**AMERENUE – Callaway Plant**  
**OL Amendment #1248**  
**Replacement Steam Generators**

## EVALUATION

### 1.0 DESCRIPTION

Figure 2.1.1-1 (page 1 of 1)  
Reactor Core Safety Limits

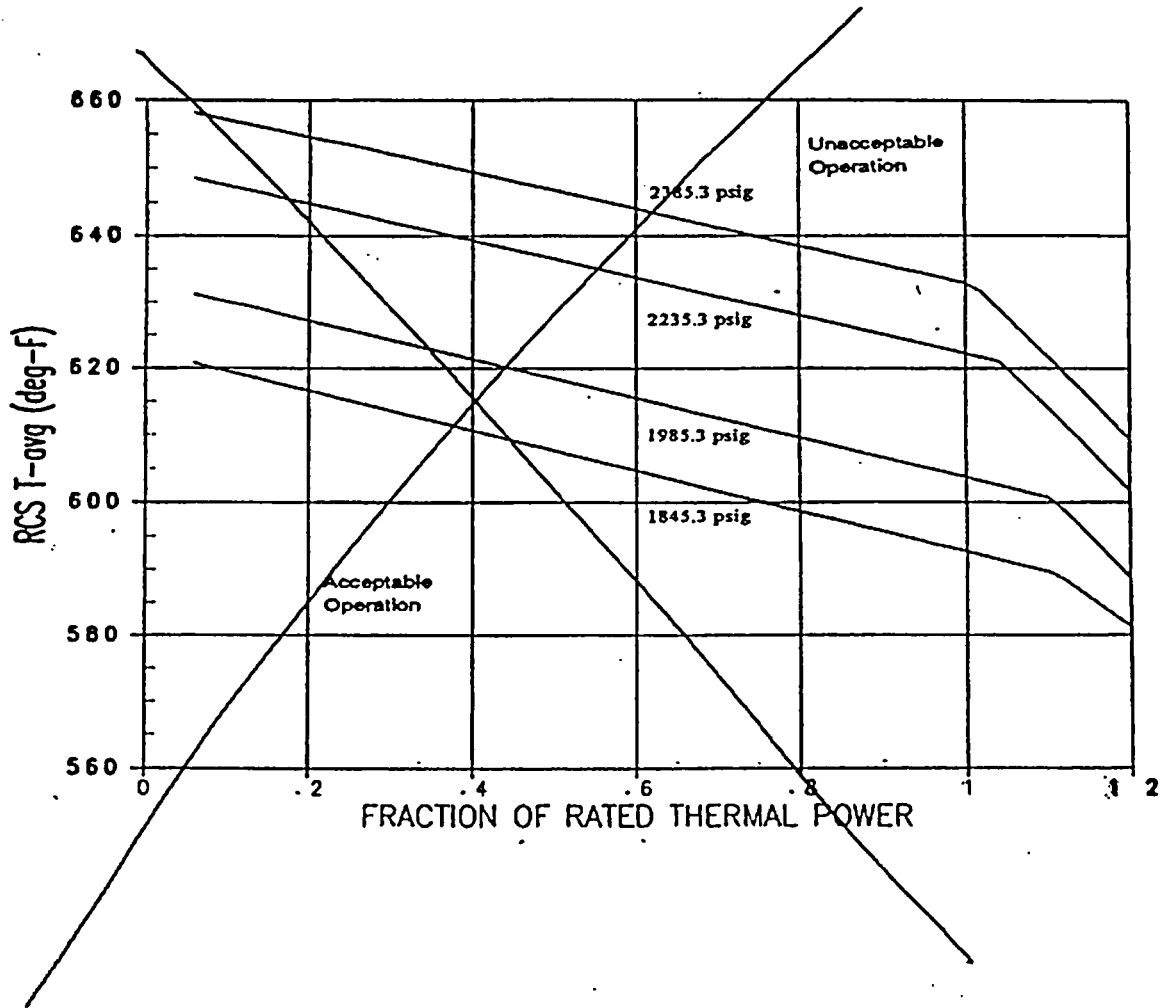
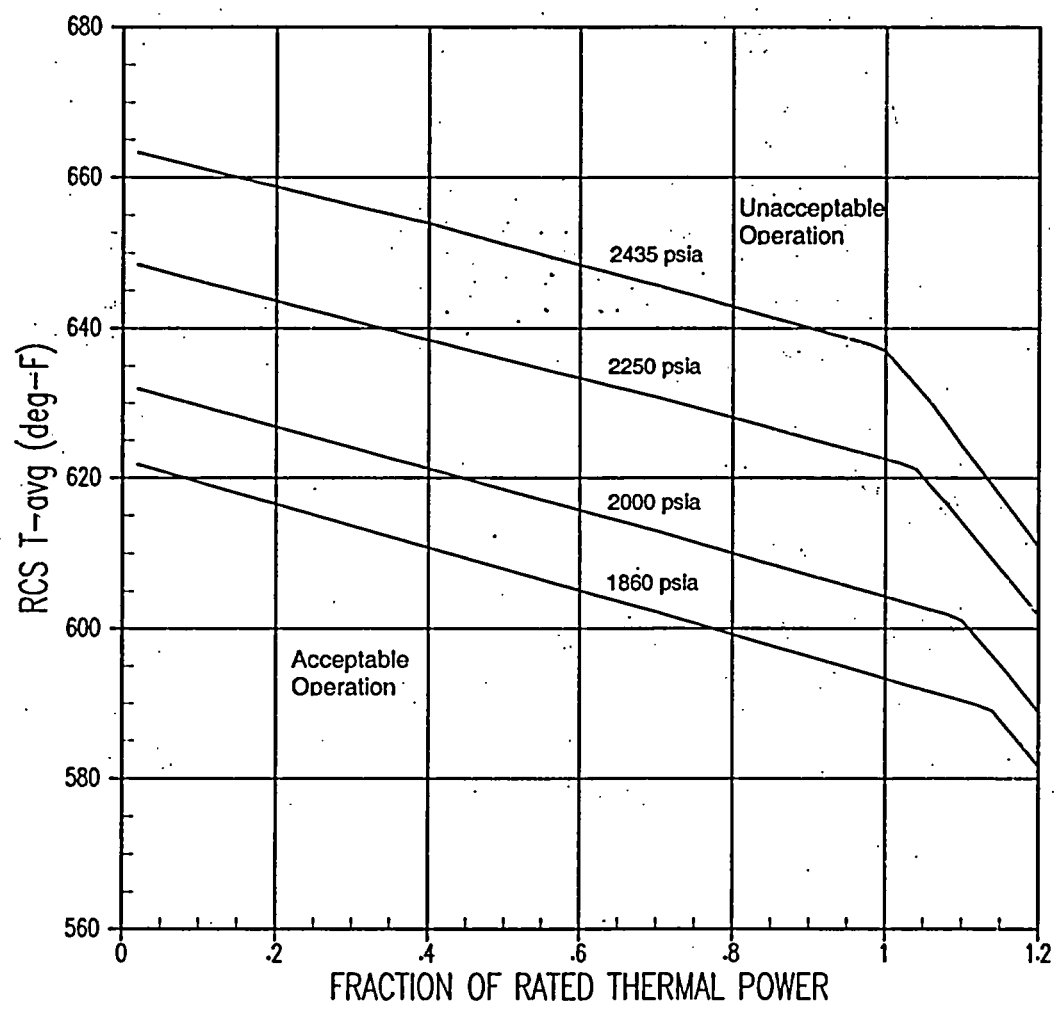
1. Figure 2.1.1-1, "Reactor Core Safety Limits," will be replaced with a new figure to reflect the replacement steam generators and associated safety analyses.
2. Condition W in LCO 3.3.1, "Reactor Trip System (RTS) Instrumentation," will no longer be used. RTS Function 14.c in TS Table 3.3.1-1 will be deleted. The Trip Time Delay (TTD) portion of the Steam Generator (SG) Water Level Low-Low trip function will be deleted during Refuel 14, including the Vessel  $\Delta T$  Equivalent (Power-1, Power-2) channels and the delay timers.

*Replace with revised figure*
